SUBJECT: COMANCHE PEAK NUCLEAR POWER PLANT, UNITS 3 AND 4
DOCKET NUMBERS 52-034 AND 52-035
SUPPLEMENTAL INFORMATION FOR THE RESPONSE TO REQUEST FOR
ADDITIONAL INFORMATION NO. 1889

**Supplemental Response to
Request for Additional Information No. 1889 (CP RAI #11)**

RAI NO.: 1889 (CP RAI #11)

SRP SECTION: 02.05.02 – VIBRATORY GROUND MOTION

Figure 2.5.2-215 PGA Rock Seismic Hazard Curves for all Sources and for New Madrid Faults Alone

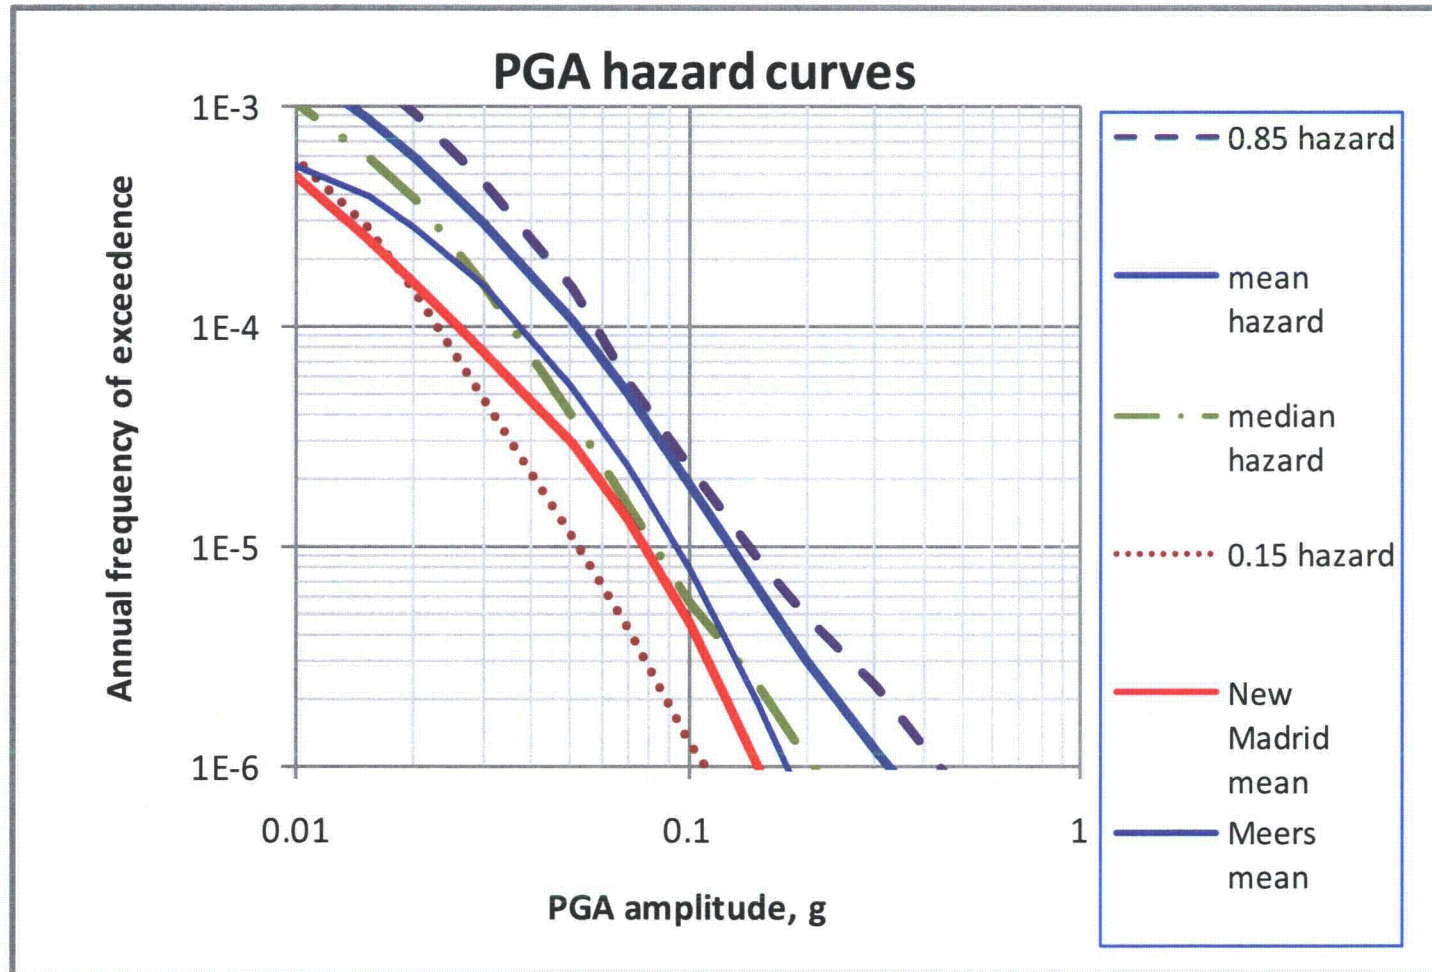
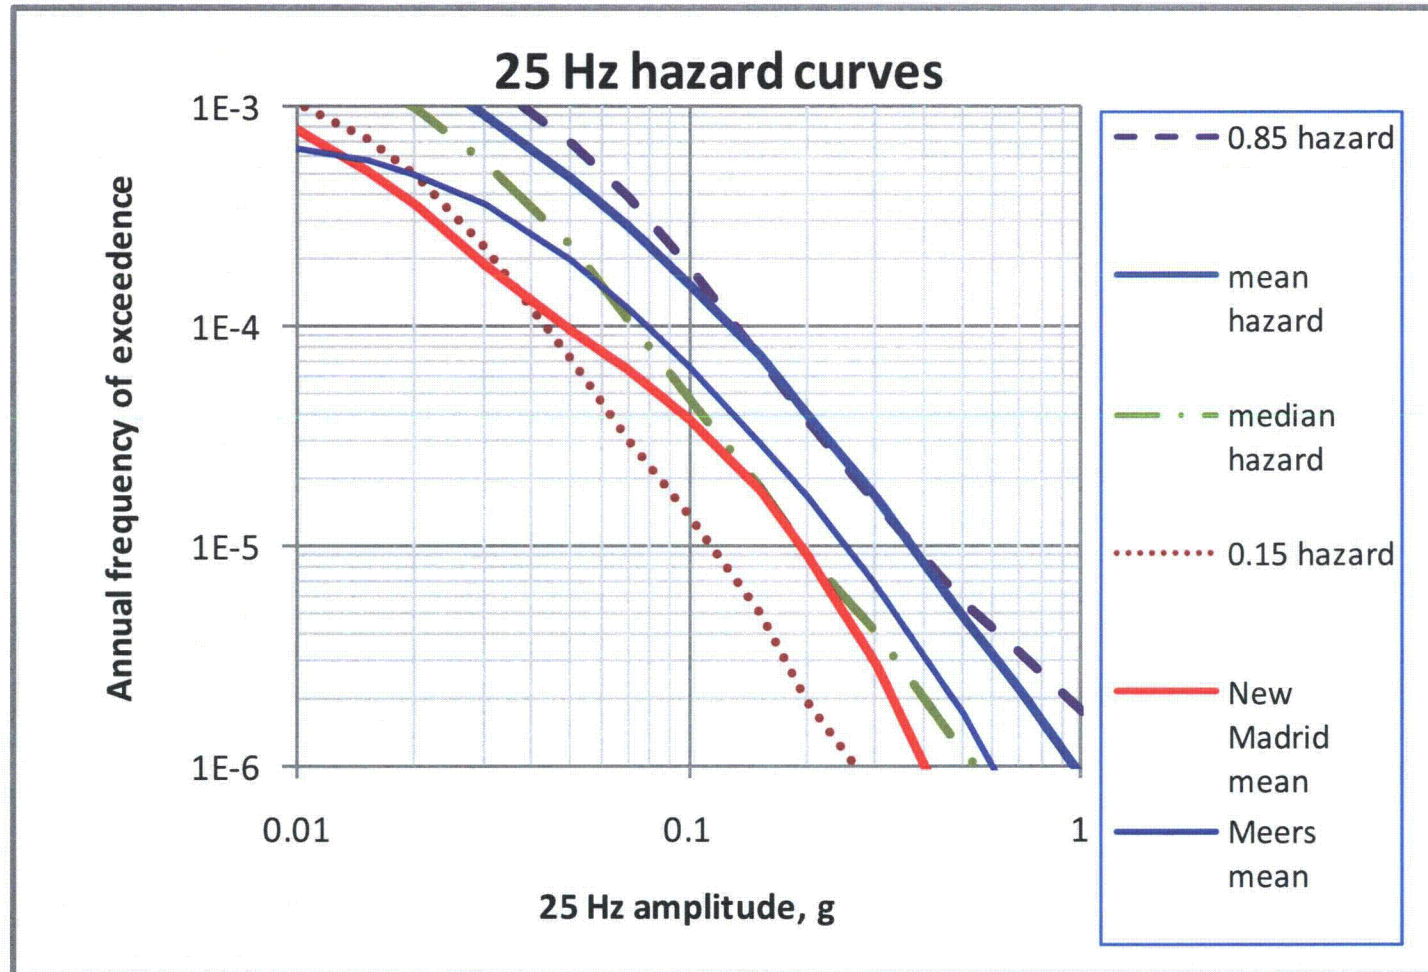
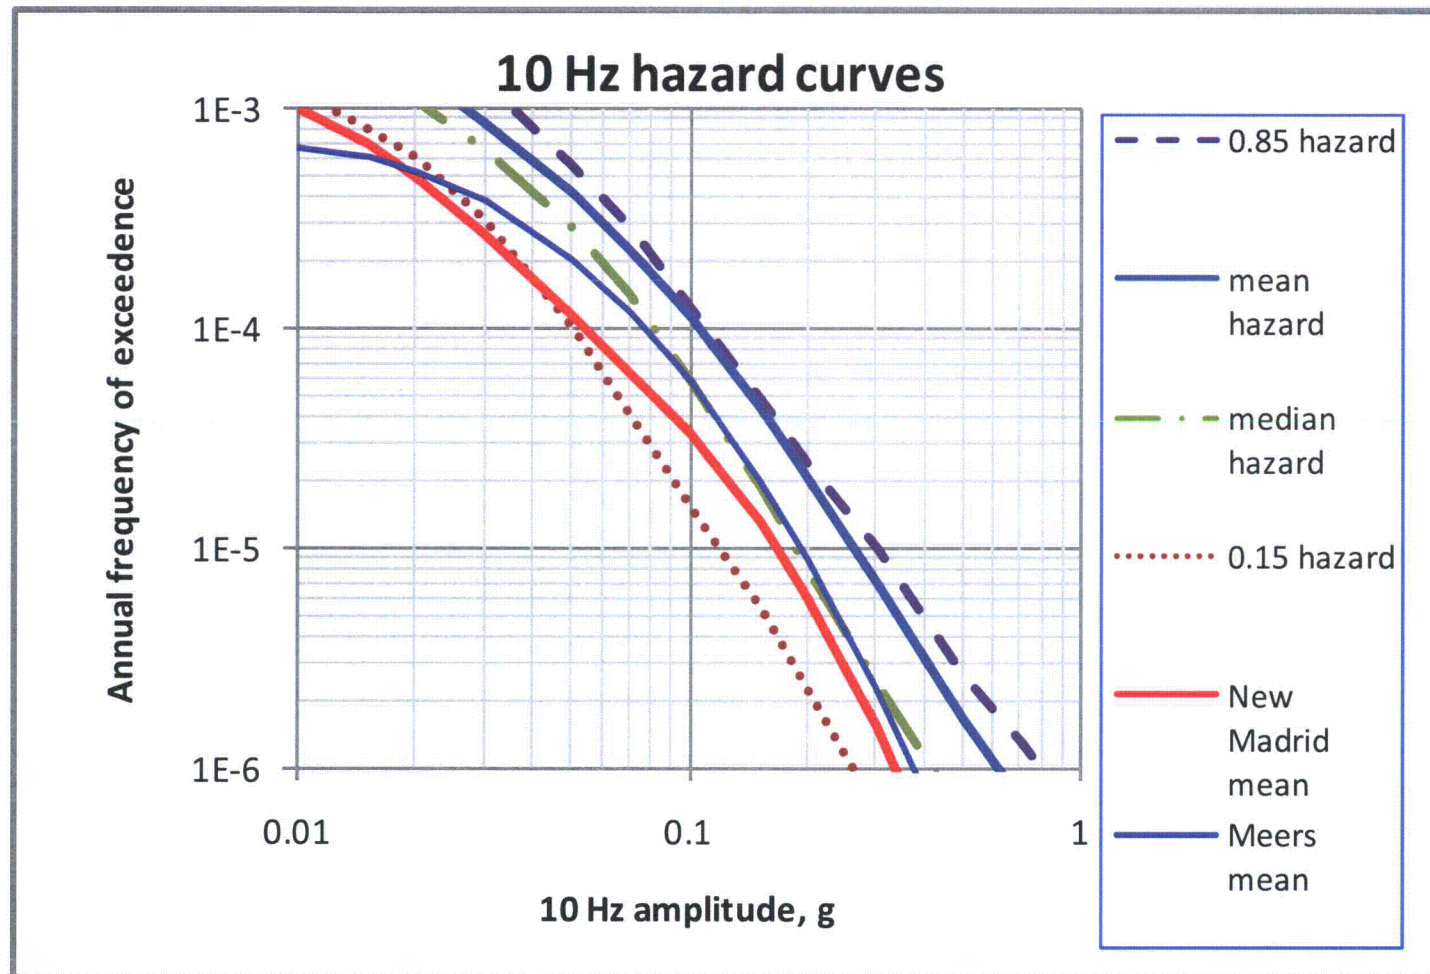
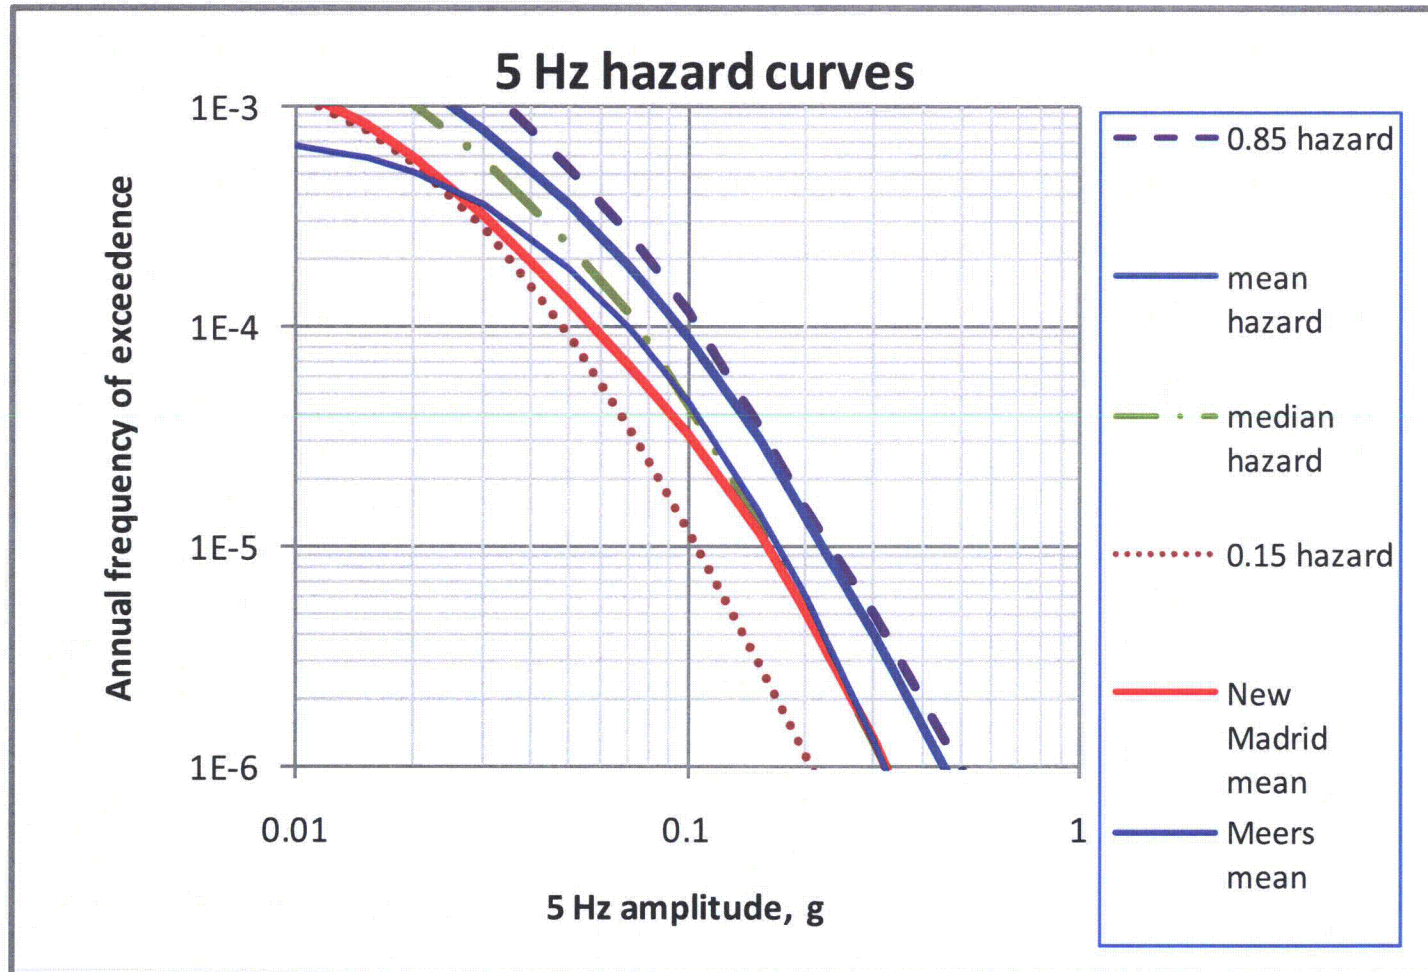
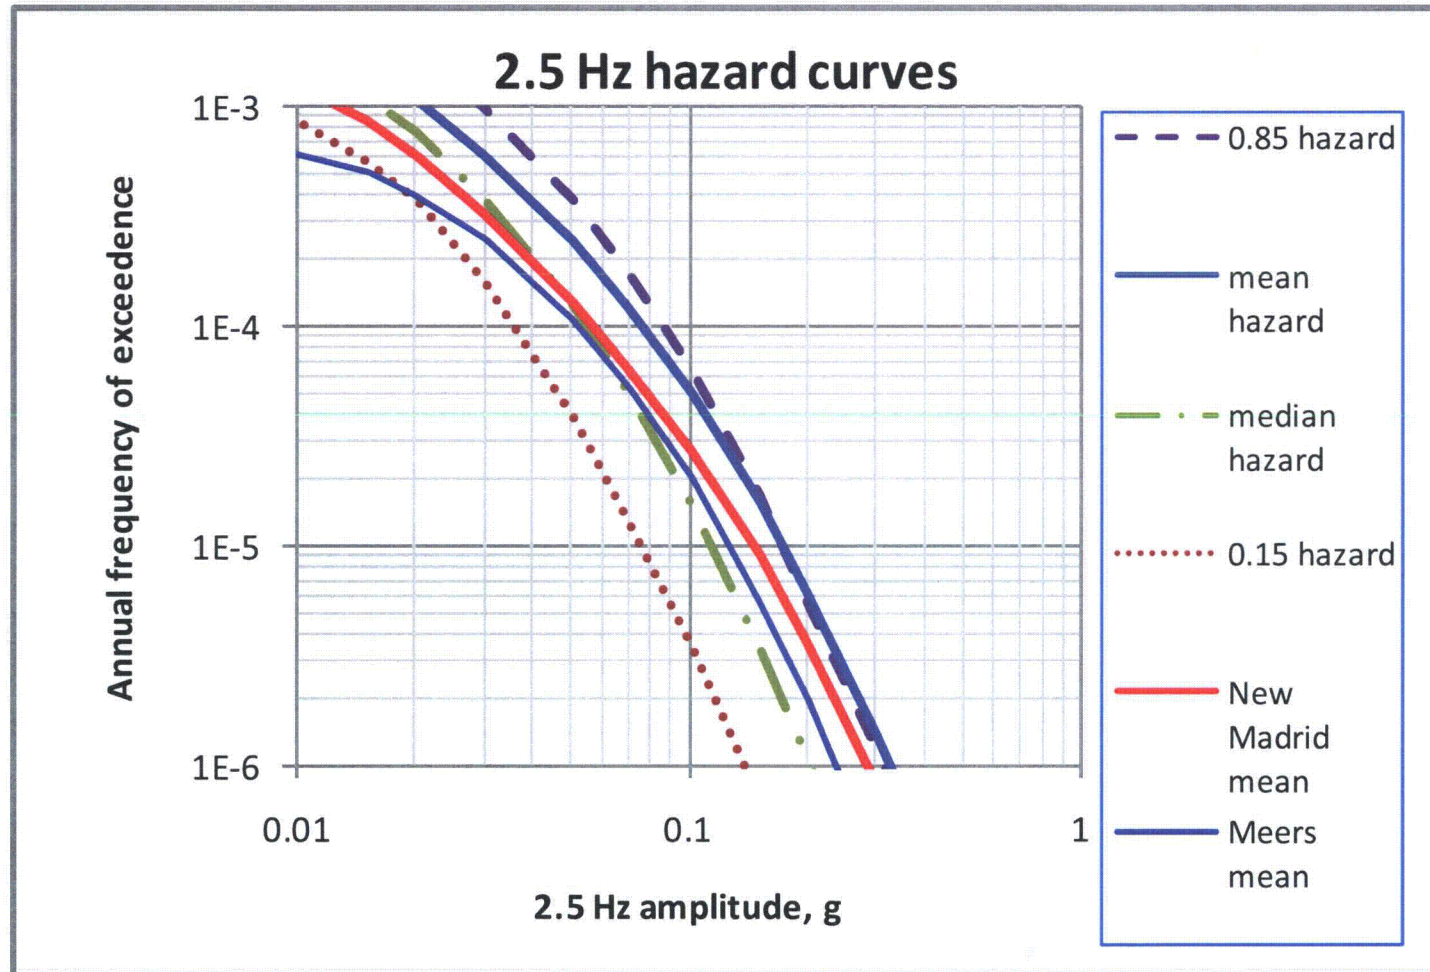
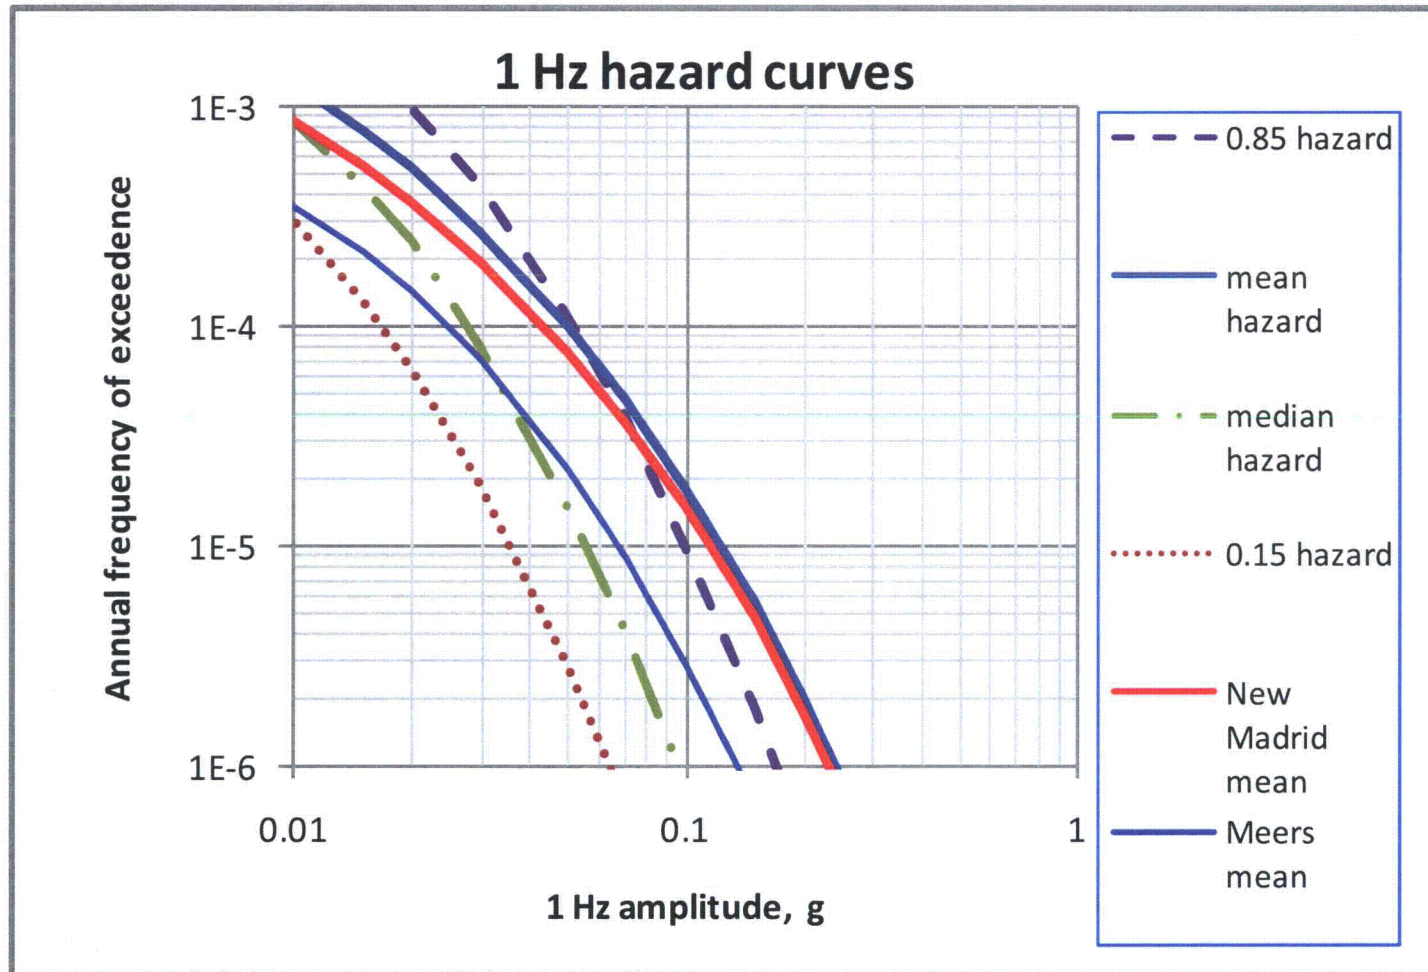
The Meers fault is about 270 km from the CPNPP site with an Mmax distribution of 6.85 ± 0.15 (Table 2.5.2-213) and a dominant recurrence interval of 1265 years. Considering these parameters, the staff is unclear why the Meers source's contribution to mean hazard is almost invisible in the 1 to 2.5 Hz deaggregations, and only a small contributor to the 5 to 10 Hz deaggregations of Figures 2.5.2-223 to 227. Please explain the near invisibility of the Meers source in FSAR Figures 2.5.2-223 to 227.

Figures 2.5.2-215 through 2.5.2-221 show total rock hazard as the mean, 15th, 50th, and 85th fractile curves for the EPRI-SOG sources plus the Meers fault and New Madrid faults, using the EPRI ground motion equations (Reference 2.5-401) with the EPRI aleatory uncertainties (Reference 2.5-403) and no CAV filter. The total mean and fractile rock hazard curves are shown for all sources. In addition, the mean hazard from the New Madrid faults is shown (this is included in the total curves). The Meers fault and New Madrid faults dominate the hazard for frequencies of 5 Hz and lower, and contribute a significant part of the hazard for 10 Hz amplitudes and higher. One of the characteristics of the hazard curves at low spectral frequencies (2.5 Hz and lower) is that the mean rock hazard curves exceeded the 85th fractile at high ground motion amplitudes. This exceedance occurs because the New Madrid seismic source dominates the hazard, and is caused by a few EPRI ground motion equations (Reference 2.5-401) indicating relatively high hazards for the large distance between the New Madrid seismic source and the CPNPP Units 3 and 4 site.
